Red Rock State Park Issues of Concern

The following comments are based on the Preliminary Planning Concepts for the Red Rock State Park General Plan Revision that were first provided at the March 26 and 27, 2019 public meetings (Concepts document). We understand that Concepts #1-4 are preliminary, however they are not accompanied by enough resource information for the reader to provide informed comments on these concepts. In addition, the maps on which the concepts are based are incomplete and do not reflect the actual existing condition of the transportation system as depicted on Red Rock Canyon State Park maps (attached).

<u>Figure 1 – Potential access route to Nightmare Gulch trailhead. This would be closer to the Gulch than the hiking trail shown in Concepts #1-4.</u>

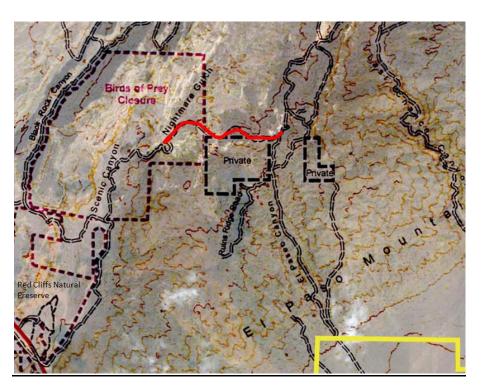
A parking area closer to the northeast end should be added if possible. This area could be accessed from El Paseo Road where it intersects with Cudahy Creek Road as shown in Concepts 1-4, but should be located closer to the more scenic section of the Gulch.

A parking area near the northeast end of the Gulch is also shown adjacent to the private property inholding in Concept #1, however in this Concept the road has been converted to a hiking trail so it is unclear why a parking area is marked at this location. The road to this location is shown in the figure below and is accessed via the gate that is located past the Snow White Mine on El Paseo Rd. We

strongly suggest allowing the road to remain open and placing a parking area at the location shown in Concept 1.

Figure showing trail #1 relocated around Cudahy Camp

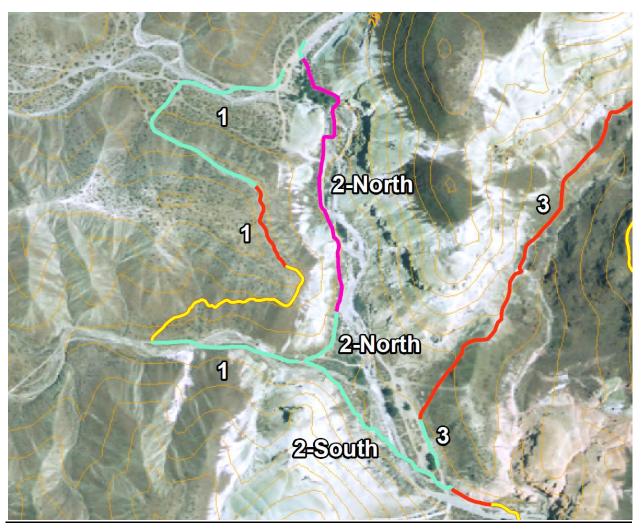
Establish a route around the Cudahy Site. Improvement and extension of the mining claim access road adjacent to the Cudahy site would establish connectivity through this important area and would relocate the route away from the proposed Cudahy Natural Preserve. A 2007 study by California Geologic Survey identified a potential route, see the attached map, as #1 in Figure below.

Approximately ½ mile of new route construction (yellow) would be required to connect the upper section of Last Chance Canyon Road with Cudahy Creek Road. This route would address the problem of limited east-west connectivity as well as reducing potential impacts to sensitive resources. We suggest that this reroute be completed as a site specific CEQA project separate from the General Plan Revision.

Figure 2 - Unnamed trail adjacent to El Paseo Rd

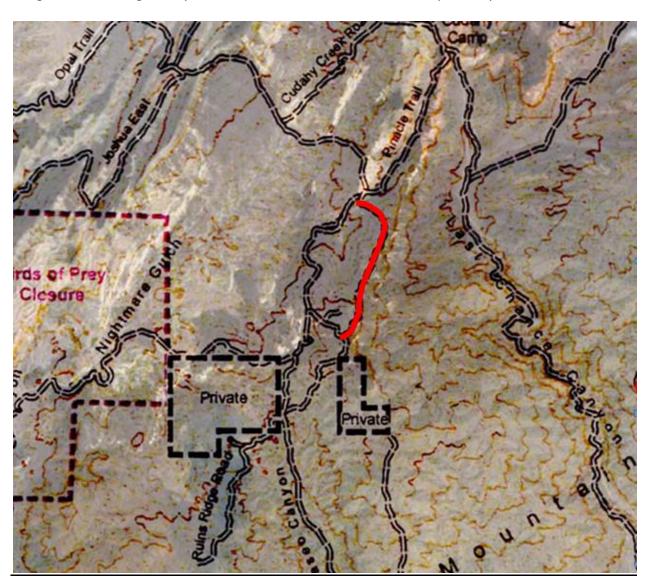
There is an unnamed trail that runs parallel to Ed Paseo Road. It originates near the intersection of El Paso and Pinnacles Roads and connects back to El Paso Rd near the Snow White Mine. The approach to this trail has excessive grade similar to Pinnacles Road and this could be partially addressed by improving the old road bed at the El Paso intersection. The trail appears to have had little use. It is in

excellent condition. It has a rocky surface that resists erosion, but makes the surface uneven and unattractive as a hiking trail. The trail runs along the ridge top and has outstanding views of Last Chance Canyon and the Nightmare Gulch drainage. Ideally it would be retained as a trail for street legal 4X4's or green sticker registered vehicles. As a minimum it should be retained as a hiking trail, although with the rough rocky surface and remote location it would probably receive little use.

Trail EP 107

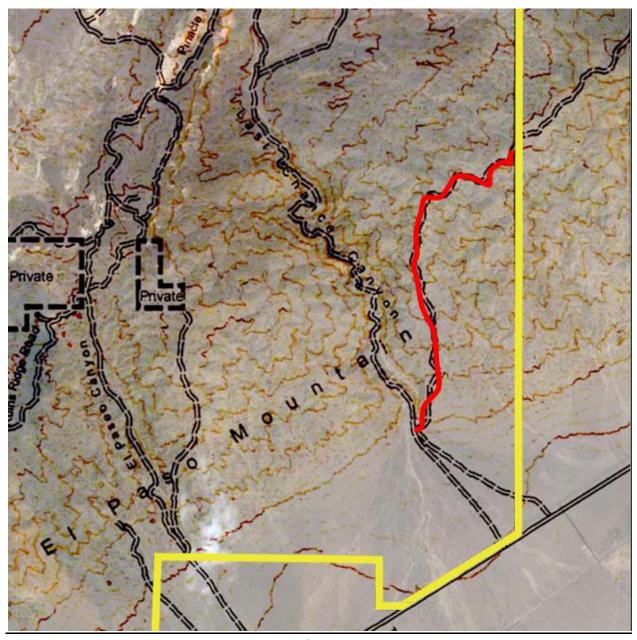
Trail EP 107 is not included in any of the concepts. The reason for this omission is not clear. This trail is a two-track route that connects the Burro Schmidt Tunnel area with lower Last Chance Canyon.

The trail is presently open from Burro Schmidt to the Park boundary, which limits the value of the BLM section of the trail and encourages trespass onto the closed portion of the trail. Barring significant resource issues that cannot be mitigated this trail should be retained as part of the primitive road system.
